Expert Report of Greg Karras

Communities for a Better Environment (CBE)

Phillips 66 Company Propane Recovery Project

Recirculated Draft Environmental Impact Report (RDEIR)

SOURCE: Phillips 66 Company
 Phillips 66 Propane Recovery Project . 120546
Figure 3-6 Revised
 Proposed Refinery Fuel Gas System Block Flow Diagram

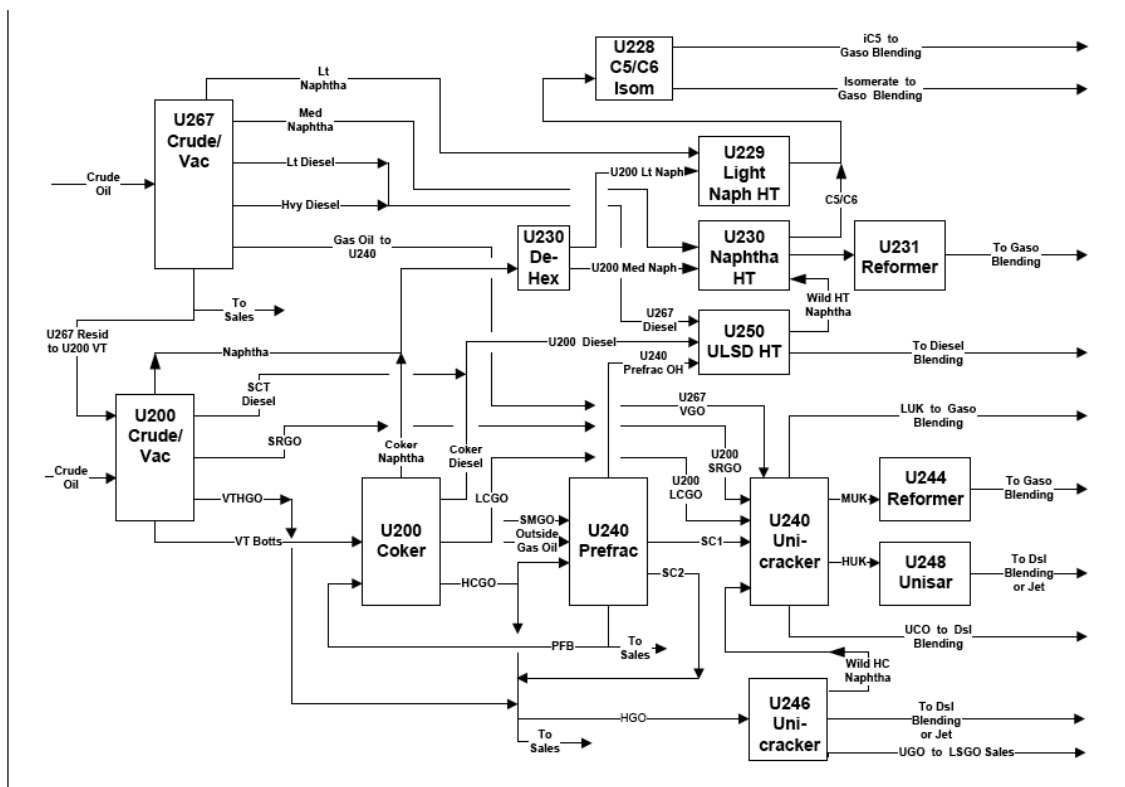
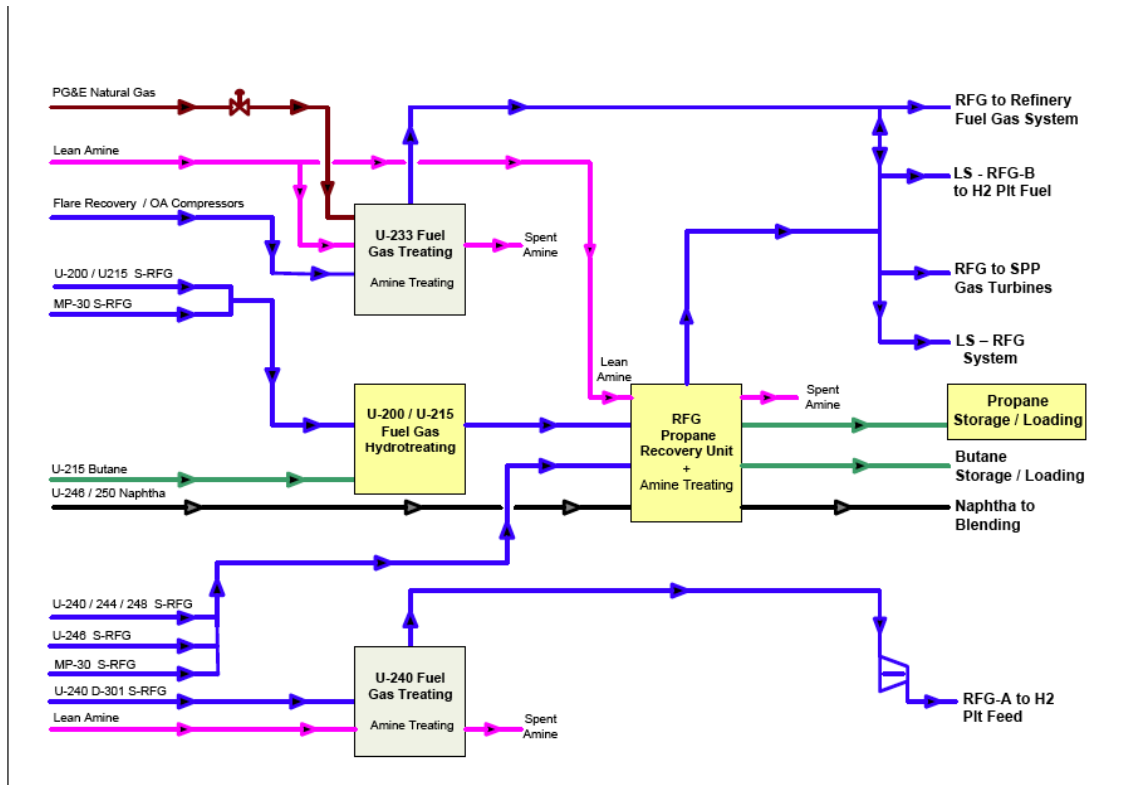
9. Sources of the LPG to be recovered, as described in the DEIR, did *not* include several streams feeding ‘RFG-A.’ (DEIR Figure 3-6.) These ‘RFG-A’ streams are now included among those from which LPG could be recovered. (RDEIR Figure 3-6.) This change in the project description reveals undisclosed changes in hydrogen plant feed and further implicates feedstock from the Santa Maria facility (see figs. 3-4, 3-6), but the RDEIR includes no discussion of any potential effects from this change in the project.

10. Additional hydrocarbon streams would be treated by the proposed new hydrotreater, but this change and its implications are not discussed in the RDEIR. Naphtha streams from the heavy gas oil hydrocracker (Unit 246) and the ULSD diesel hydrotreater (U250) are fed to reforming units U231 and U244 now, but the revised project description would instead route them through the new hydrotreater. (Compare DEIR and RDEIR figures 3-4, 3-5, and 3-6.)

36. Importantly, an otherwise unexplained change in the project description is informed by the ‘current conditions’ and ‘SMF project’ results for naphtha in Table 1. Naphtha from the Rodeo heavy gas oil hydrocracker (Unit 246) and the ULSD diesel hydrotreater (U250) is routed through the proposed new ‘fuel gas’ hydrotreater in Revised Figure 3-6 of the RDEIR. These streams were routed through the proposed LPG recovery but *not* the proposed new hydrotreater in Figure 3-6 of the June 2013 DEIR. Further, these U246 and U250 streams are ‘wild naphtha’ derived at least in part from processing the SMF gas oil (‘SMGO;’ see Figure 3-4.⁵¹) Finally, these wild naphtha streams are now fed through other processes to reforming units U231 and U244 (see Figure 3-4), but revised Figure 3-6 shows the project re-routing them to naphtha blending instead. In sum, these naphtha streams are fed to the Rodeo reformers now but the revised LPG recovery proposal would instead route them through the new hydrotreater. For convenient review, RDEIR Revised Figure 3-6, RDEIR Figure 3-4, and original Figure 3-6 from the June 2013 DEIR are excerpted below.
